BEFORE THE CITY COUNCIL
CITY OF SHERWOOD, OREGON

IN THE MATTER OF AN APPEAL OF THE
PLANNING COMMISSION DECISION FOR
THE COMFORT SUITES HOTEL AND
CONFERENCE CENTER WITH RESPECT
TO FINDINGS AND A CONDITION
RELATED TO THE LOCATION OF
ACCESS

FINAL ORDER 2007-002
SP 07-01, CUP 07-03

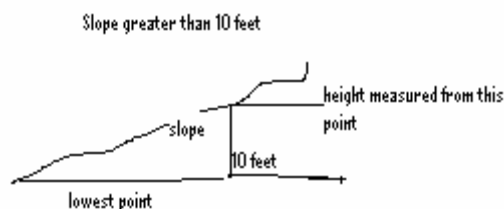
There is an existing cell tower and concrete building that, from the submitted plans, appear to be fifteen (15) feet from the adjoining residential properties. These structures are considered pre-existing non-conforming and should they be removed for any reason in the future, they will have to be replaced so that they meet the required twenty (20) foot setback.

The building was designed to be 100 feet from the residentially zoned properties so as to allow a 50 foot building. The submitted elevations on sheet A006, specifically the southeast elevation, shows the height of the building from the finished floor at the front of the hotel to the midpoint of the hip roof as forty-nine feet, nine and one-half inches (49' 9 ½ "). However, this height measurement does not take into account that the lowest grade of the building is fourteen feet, eight inches (14' 8") lower than the finished floor at the front of the hotel. Per Section 1.202.15 of the Sherwood Zoning and Community Development Code, the building height is measured from a reference datum that is an elevation "ten (10) feet higher than the lowest grade, when the sidewalk or ground surface described in 1.202.12.A [scrivener's error, should read 1.202.15.A] is more than ten (10) feet above lowest grade" (see diagram below). Therefore, the building exceeds the maximum height of fifty (50) feet by four feet, five and one-half inches (4' 5 ½ "). It seems feasible for the applicant to meet this standard by modifying the proposed grading and/or building design to ensure that the height does not exceed 50 feet when measuring the height with a reference datum 10 feet higher than the lowest grade.

FINDING: Based on the discussion above, the proposal does not fully comply with the dimensional standards because the trash enclosure is proposed within 20 feet of a residential zone and the building height exceeds the maximum for the zone by 4' 5 ½ ". This standard could be met as conditioned below.

CONDITION: Prior to final site plan approval, submit a final site plan showing the trash enclosure located at least 20 feet away from the adjacent residentially-zoned properties along with an updated approval from Pride indicating the revised location continues to be accessible to the Pride service vehicles..

CONDITION: Prior to final site plan approval, submit revised building elevations that comply with the maximum height of fifty (50) feet for the GC zone (building height is defined in Section 1.202.15 of the SZCDC).
